工程指示 / 要求簡箋(E.I.)

工程名稱：將軍澳日出康城 11

工程項目：幕牆 廠用配件 BM (扇撐和拉手) TYP

Subject **Material Submission – Midi – Submission of Sample for Hardware for Curtain Wall at Tower (MS023)**

# Tung<sup>®</sup> 2022SH超重型方槽不锈钢铰链(分左右)

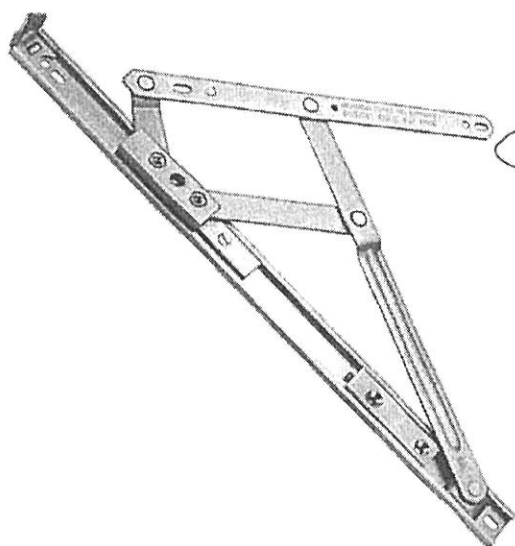
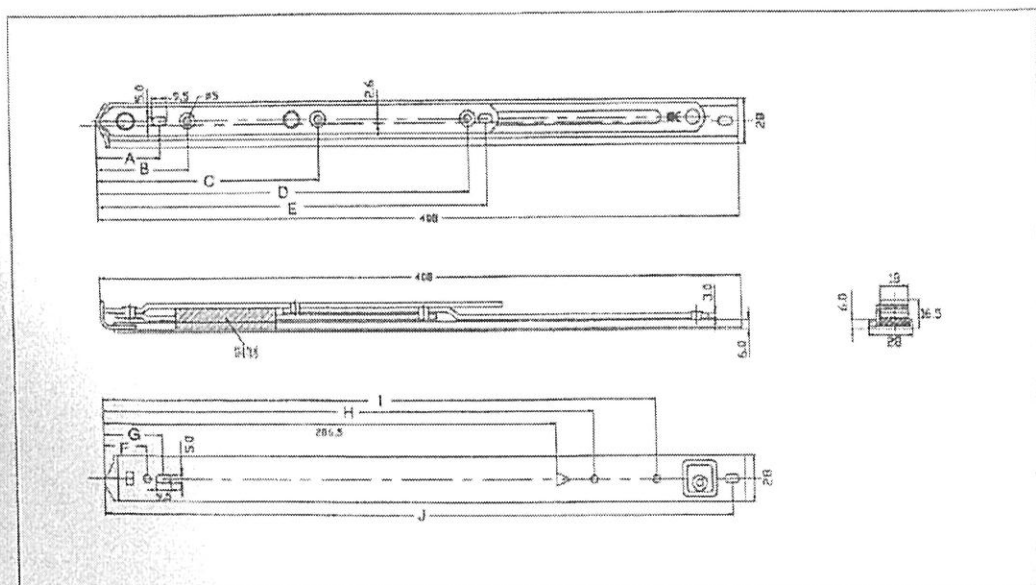
Comments REVIEW STATUS - B.  
1/ REFER TO COMMENTS FROM FACADE CONSULT ANT.  
2/ PRODUCT SHALL BE INSTALLED ACCORDING TO MANUFACTURER'S MANUAL TO ENSURE PROPER FUNCTIONING & MAINTENANCE OF CURTAIN WALL WINDOW.

**2026-001A** 拨叉长度有多种尺寸可供选择

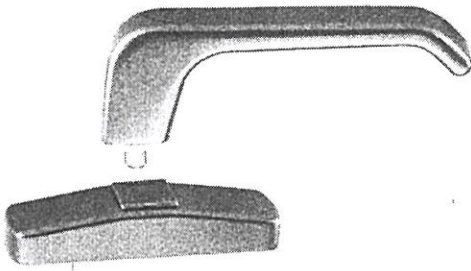
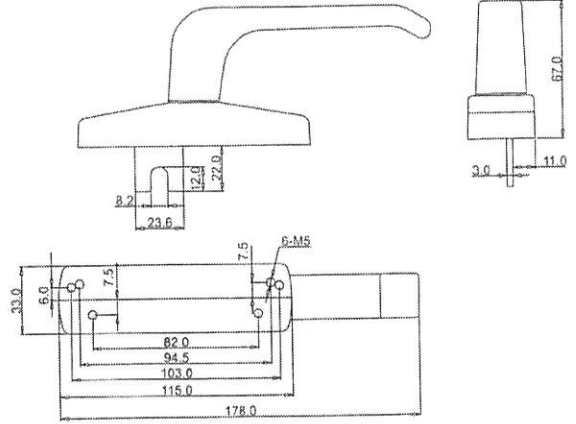
Date 16 March 2022  
 Comments **Review Status / Comment: B**  
 1/ Colour to match silver champagne cladding colour \*  
 2/ Please ensure no finger scratching when the handle is used  
 3/ All application shall comply with the Contract requirements, actual/ implied warranties (if any) and necessary statutory requirement.
